**CITY OF PORTLAND, MAINE
DEVELOPMENT REVIEW APPLICATION
PLANNING DEPARTMENT PROCESSING FORM
DRC Copy**

#947
Botto's Bakery
Project Name/Description
550 - 550 Washington Ave, Portland Maine 04103
Address of Proposed Site
166 F004
Assessor's Reference: Chart-Block-Lot

Re: Staff Site Plan Approval
MATHEWS BAKERY INC. ADDITION
550 Washington Avenue, Portland, Maine

FINAL PLANNY
 SITE PLAN 'A'
A-1

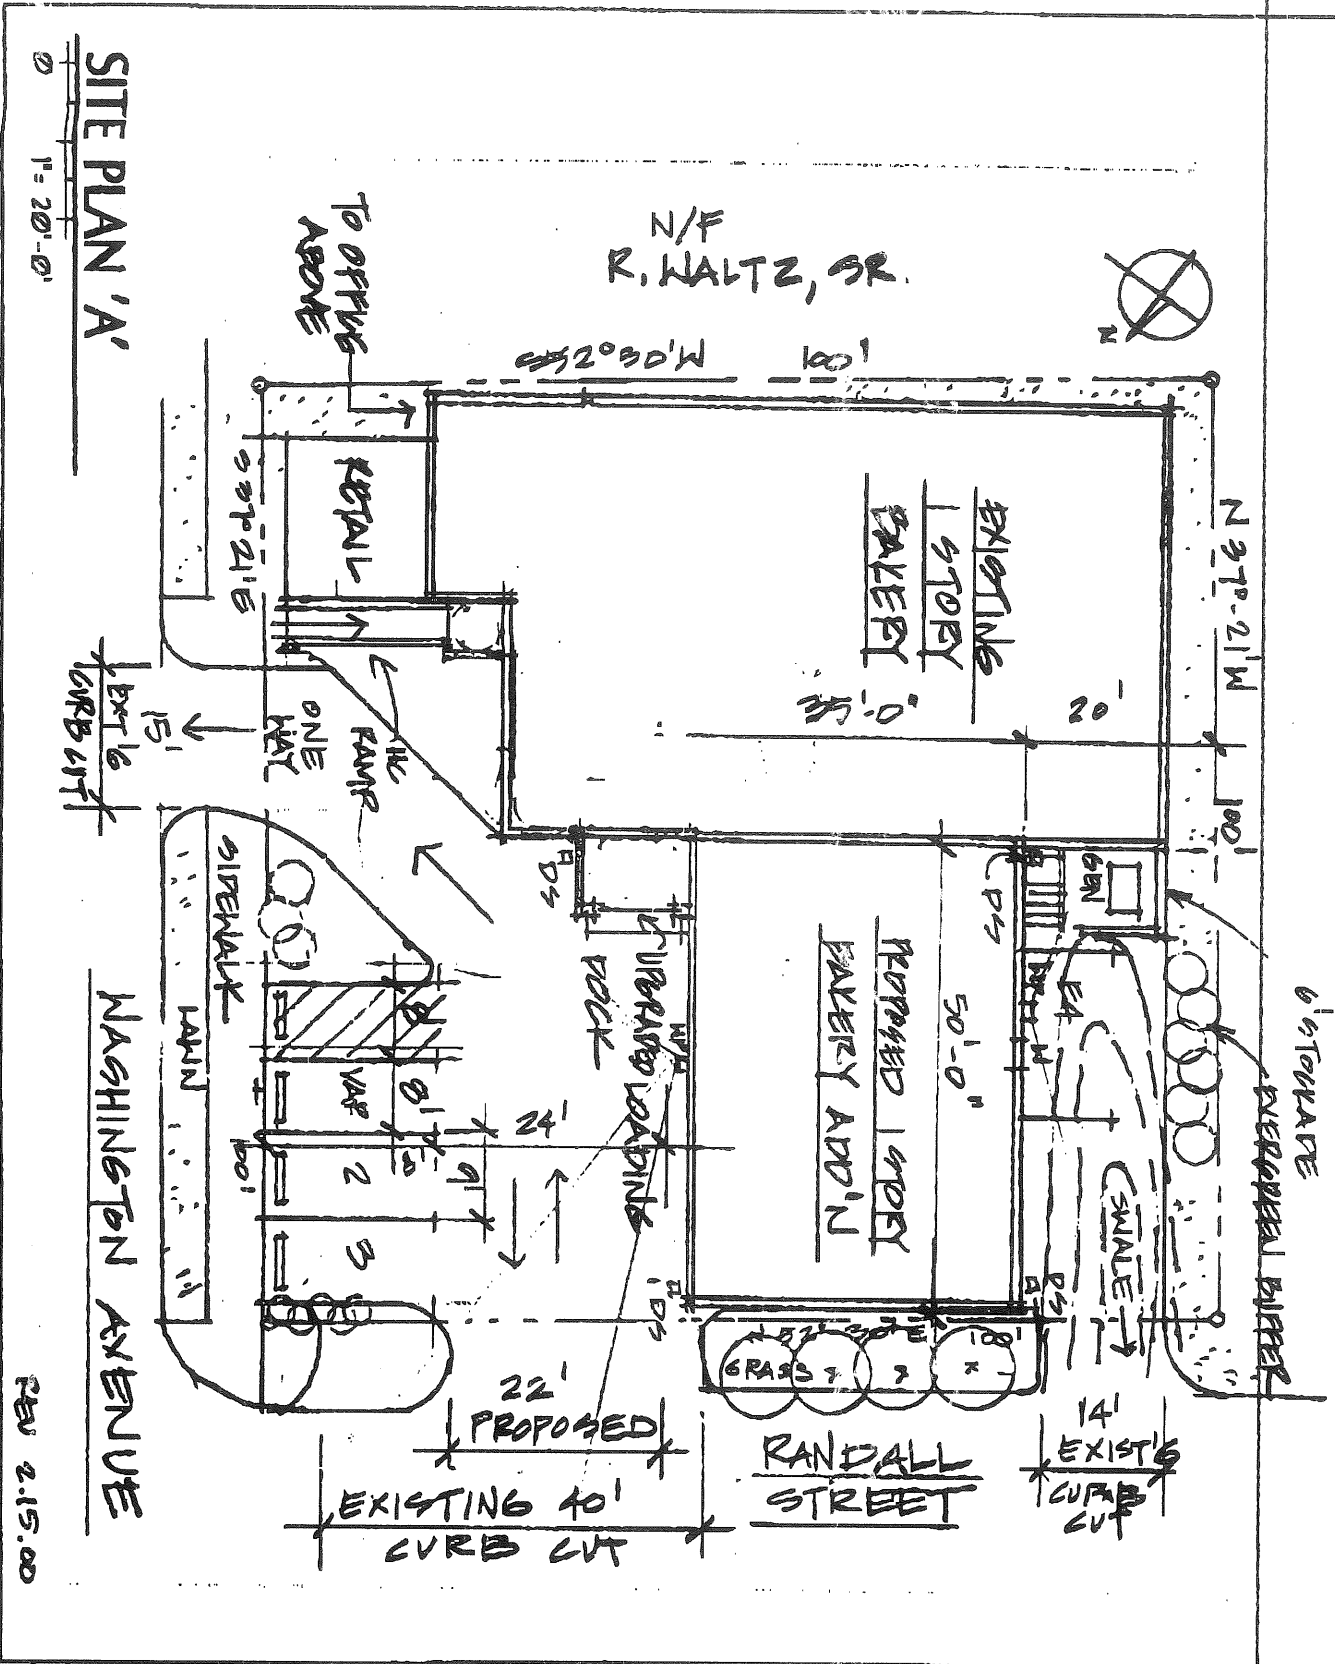
- ① Note drainage swale along NW side of addition to sheet flow roof of site drainage to Randall Street.
- ② D/S = downspout onto grade splashblocks to control roof water - water to sheet flow to Randall & Washington Ave.
- ③ Please forward comments to Alex Jagerman for his ~~the~~ Wed 10am staff meeting.

SITE LIGHTING
PLAN
Reduced

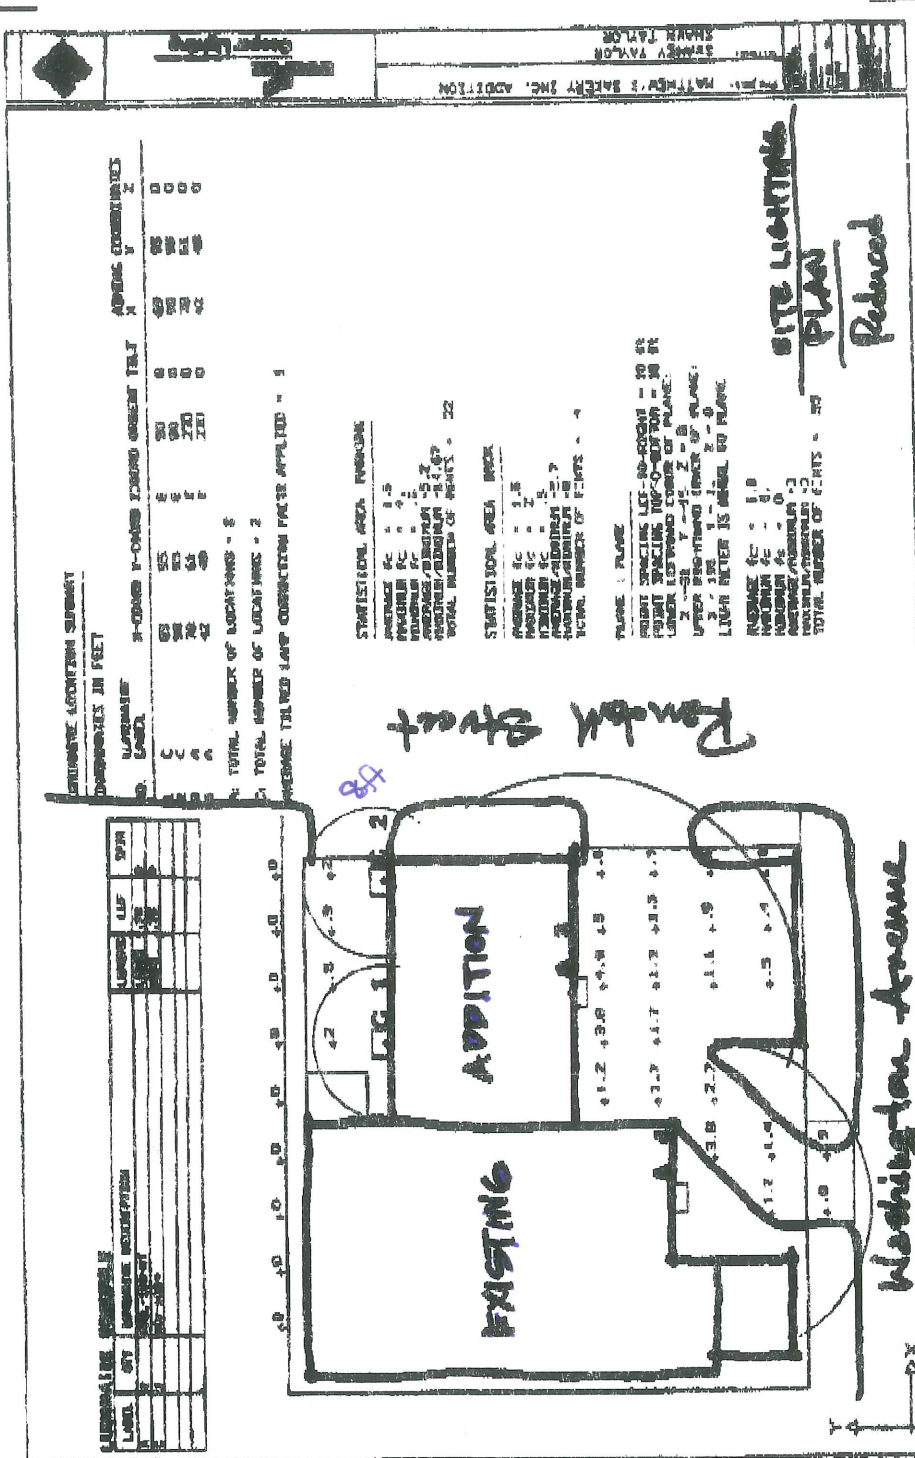
- 1 - that all wall packs for lighting be full cut-off wall packs as shown by the applicant as "Type C"
- 2 - that the applicant submit a detail of the pressure treated lattice fence proposed as screening for the roof top emergency generator.

SITE PLAN 'A'

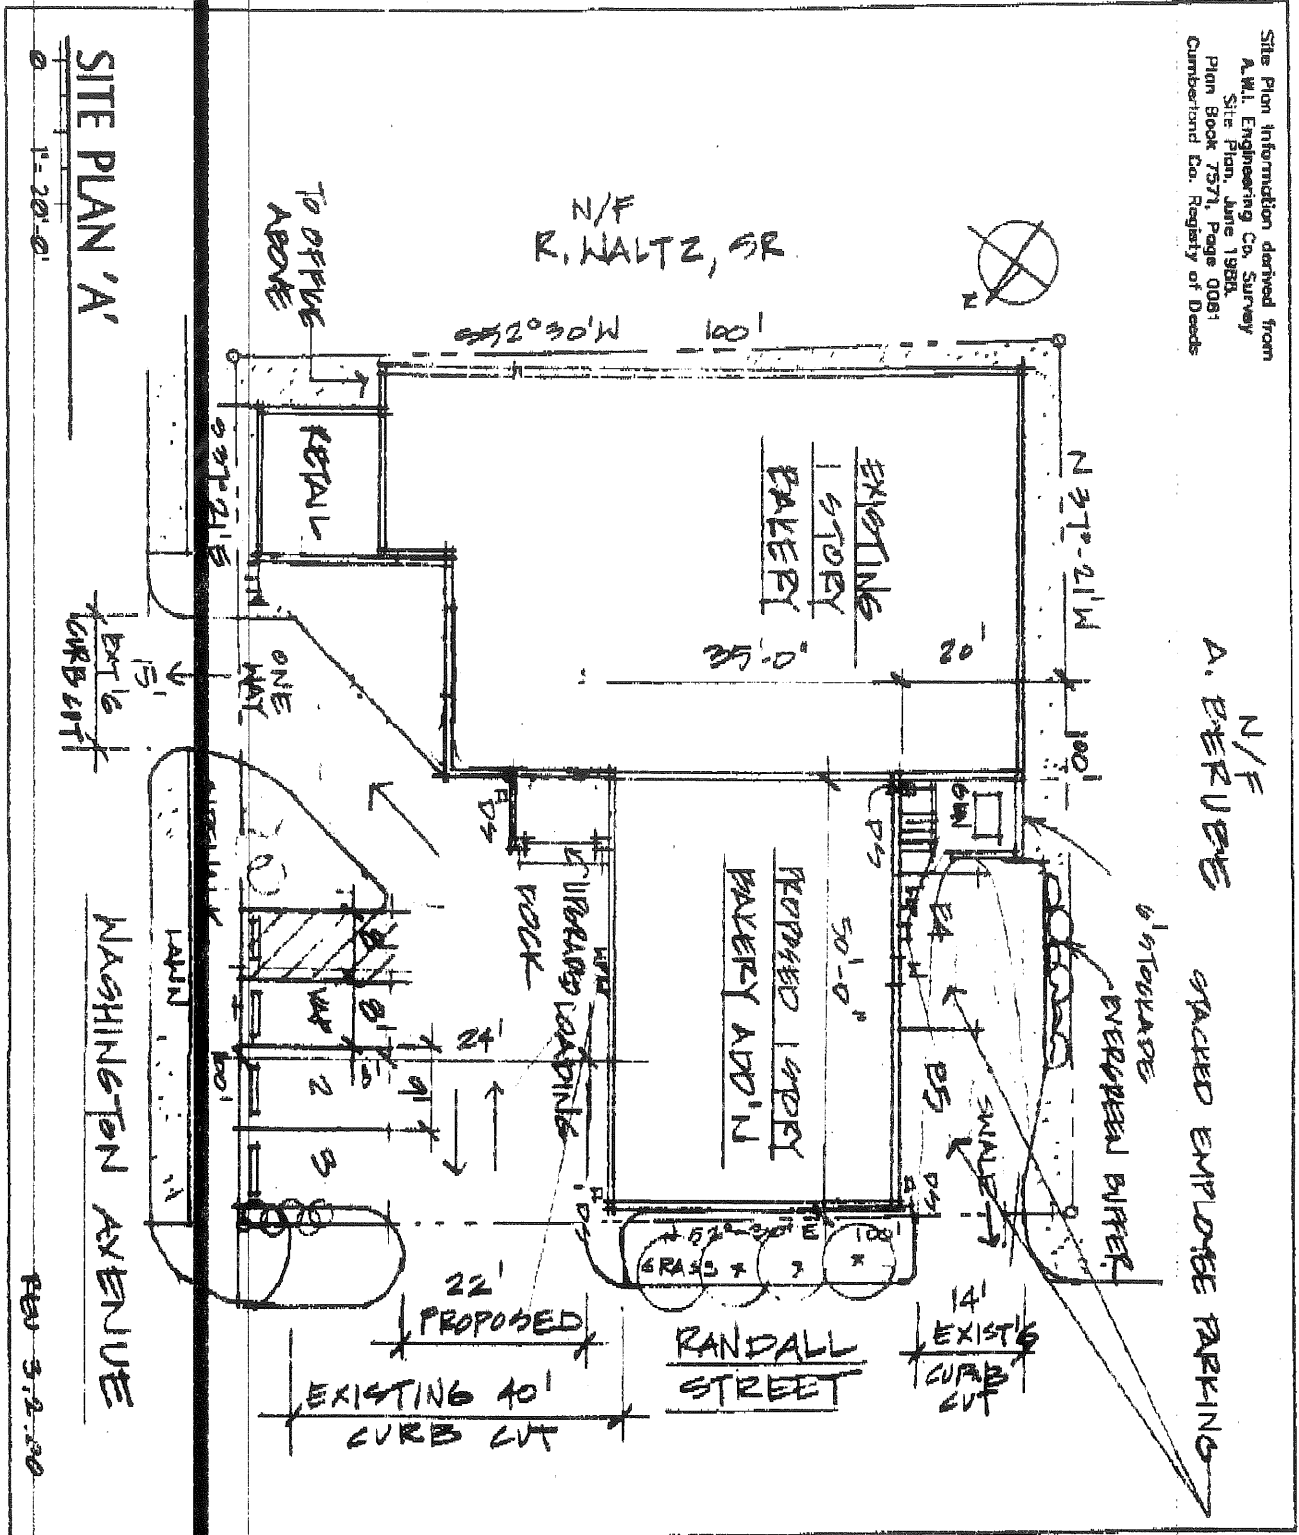
MY CLIENT HAS ASKED US TO LOOK AT WIDENING THE THROAT TO 25'-6" FROM THE APPROVED 22'-0" FOR HIS ACCESS TO/FROM RUSSELL STREET.
